**COMMISSION OF ARCHITECTURAL REVIEW
STAFF REPORT
June 26, 2018 Meeting**

12. **COA-036154-2018** (B. Robinson)

**1901-1903 O Street
Union Hill Old and Historic District**

Construct a new duplex.

1925 Sanborn Map of the 1900 block of O Street

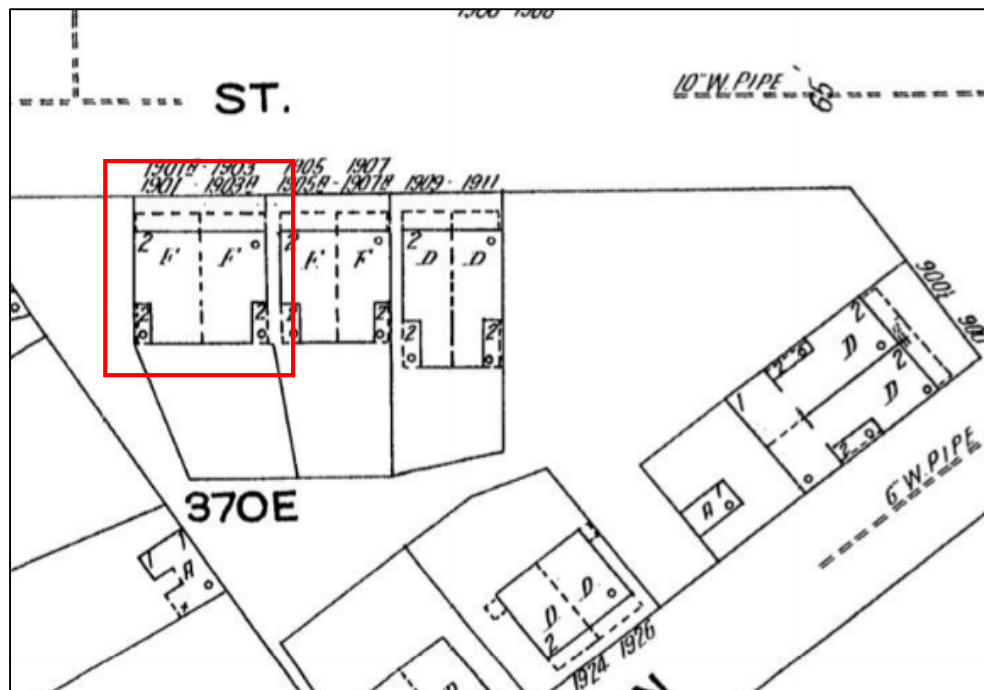
There are no adjacent buildings to the proposed structure on the subject block. The historic pattern for the block is shown below.
